TO:	CHAIR AND MEMBERS PLANNING & ENVIRONMENT COMMITTEE MEETING ON MONDAY AUGUST 28, 2017
FROM:	JOHN M. FLEMING MANAGING DIRECTOR, PLANNING AND CITY PLANNER
SUBJECT:	REQUEST FOR DEMOLITION OF HERITAGE DESIGNATED PROPERTIES AT 36 & 40 YORK STREET BY:THE TRICAR GROUP

Appendix D – Select Images from Urban Design Brief, dated August 8, 2017 of Proposed Development Design Concept

Above: Landscape Plan – Option 1

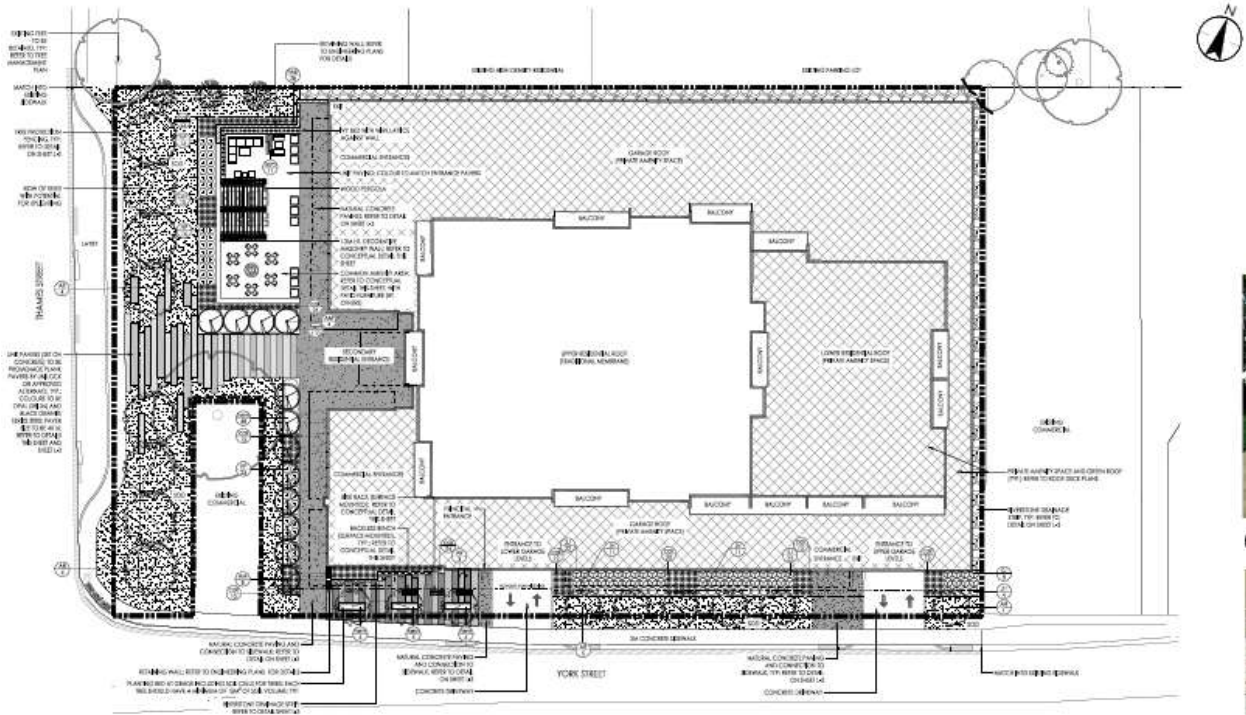
- inclusion of green roofs and amenity areas on podium and 10th floor roof
- retention of several mature trees (option 1)
- enhanced landscaping at 330 Thames Street with the inclusion of a pergola and outdoor amenity space adjacent to secondary entrance (option 1)
- landscape buffering at the edge of 24 York Street (option1)

South Elevation – Option 1 (along York Street)

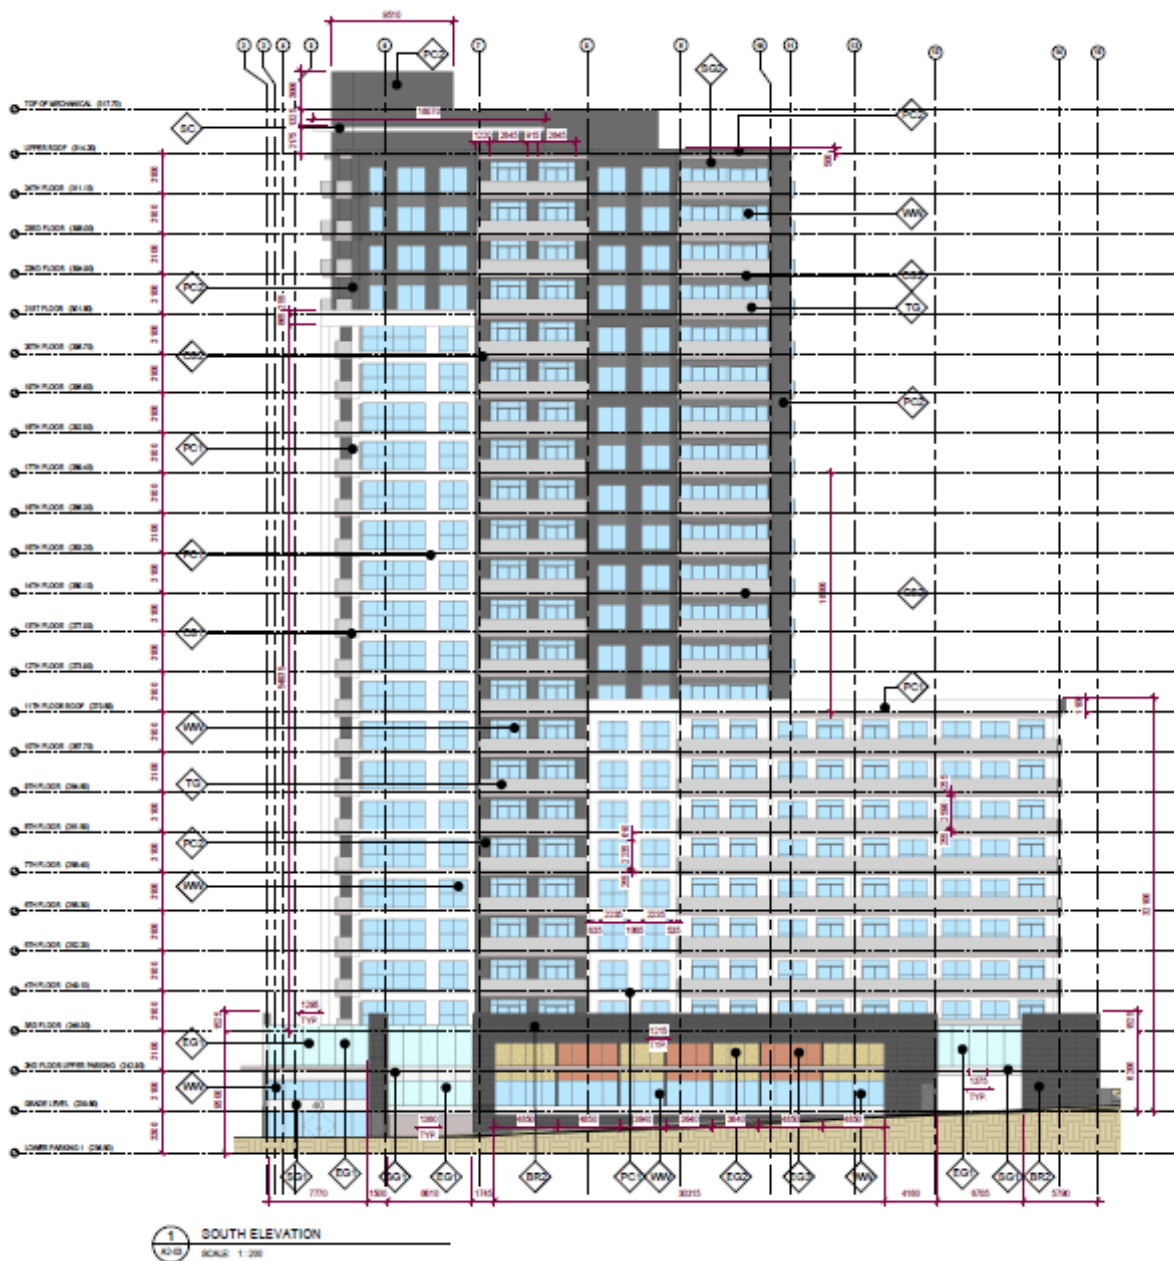
- increased parapet heights at several locations to create a more varied façade
- incorporation of glazed panels in colours red and yellow (that make reference to traditional red and London “white” brick common in the downtown district)
- mullions have been redesigned to reference a more vertical rhythm typical in the historic main street

+/-	new dev. abutting existing structures at the building line to match adjacent building height—or provide visible/apparent offset in height to maintain the visual integrity of the existing structure	interface between new development and abutting structures (particularly 24 York Street) is not sufficiently addressed or mitigated by podium height; landscaping provides some buffering; podium height is compatible with streetscape norms	
	+	with/exception of York Street new development w/in District encouraged to retain 3-4 storey height @ building line	proposed dev. is 1-3-storey/podium at the building line with defined pedestrian realm	
	+	single storey new dev, is discouraged	proposed development is 24-storeys	
	+	new dev. to build the full extent of the property width fronting the HCD streets	new development extends the full width of the property	
landscape + streetscape (6.2.3—HCD Plan)		design response/comment

D	-	discourage the placement of non-heritage service facilities such as service boxes, parking and utilities in highly visible locations	entrance and egress to parking garage is from York Street; impacts design of façade causing it to become utilitarian; safety issues with pedestrianization of street level
